### CUSTOMER PRODUCT SAFETY NOTICE & REMEDIATION ADVICE

Easy Access Attic Ladder— OX-AAL27 or OX-TAL28

#### Sold before August 2017

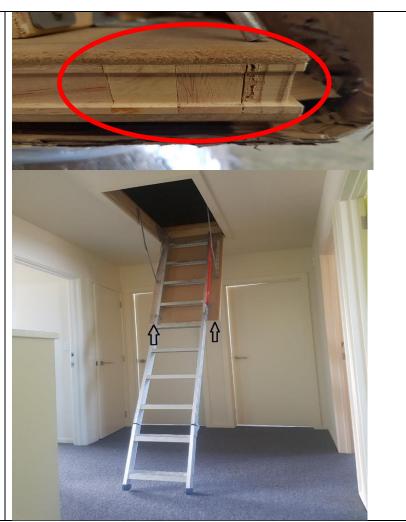
**Defect:** We have identified an issue where the mounting screws in our aluminium or timber attic ladder model *OXAAL27* and *OX-TAL28* have in some instances penetrated between the strips of the laminated timber, which could lead to them pulling free under the weight of the user.

The arrows in the second photo indicate where to inspect the ladder base frame for laminated timber.

## Step 1 Lower the base of the timber attic ladder and check that the backing timber in the frame is

laminated.

NB: If solid timber is used no remediation is required.
